Product Change Notice

JENSEN® JE3914

In order to ensure our products continue to evolve as the technological market changes, ASA Electronics will be updating the JENSEN® JE3914 television as follows:

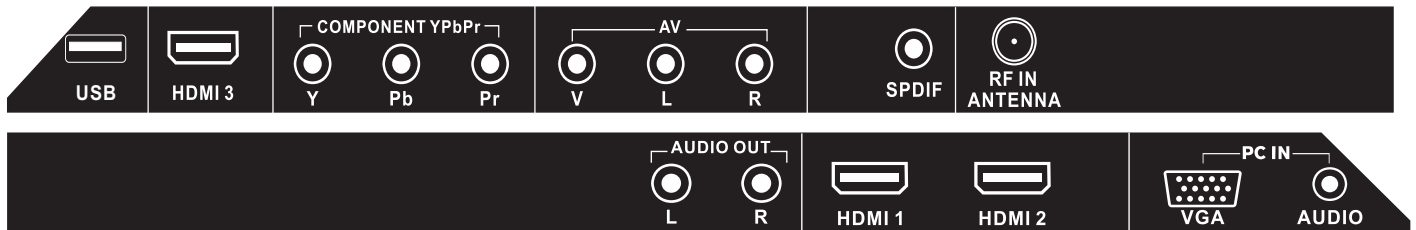
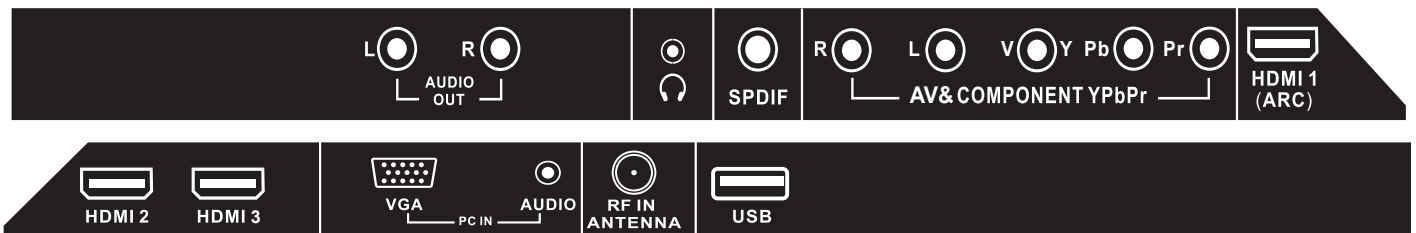
The JENSEN® JE3914 will be changing to a different IO configuration. The new Rev Level is denoted by "G" changing from the previous design of Rev Level "F". This change will be effective October 2014.

The new revision solution has common component/composite video input and shares the same I/O as Y/V (Yellow/Video). The TV detects if a CVBS or Y Pb Pr signal is connected automatically.

The Composite Video input is now shared with the Component Video input. It is no longer a separate Yellow input. HDMI1 now supports ARC 1.4, Audio Return Channel.

The new solution includes an added headphone output.
